RE: /NR536D110B/

INACTIVE STATUS

PerkinElmer LAS, Inc., by this letter, notifies you that it wishes to inactivate the following device found in NR-536-D-110-B "Registry of Radioactive Sealed Sources and Devices"

REGISTRY OF RADIOACTIVE SEALED SOURCES AND DEVICES
SAFETY EVALUATION OF DEVICE
(AMENDED IN ITS ENTIRETY)

Model Voyager ECD Module Assembly

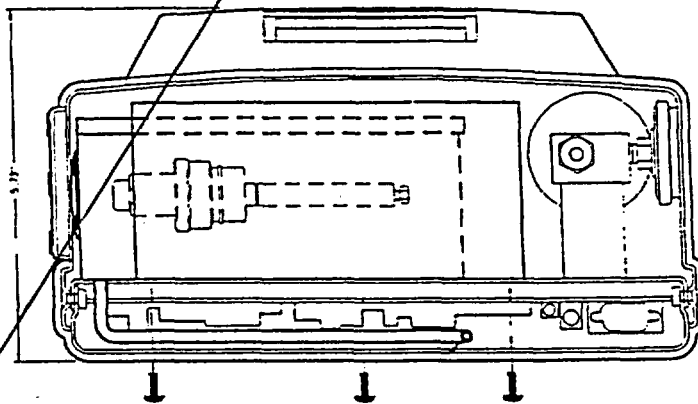
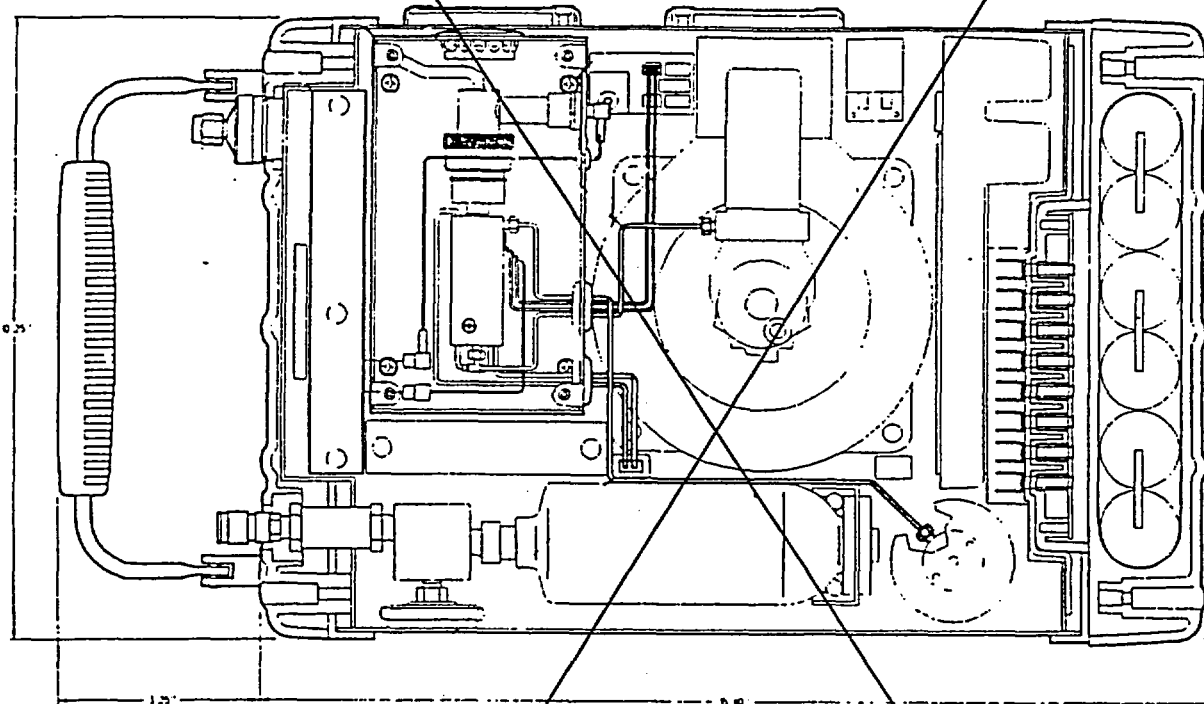
ATTACHMENT 2 & 3

Remove both attachments 2 & 3
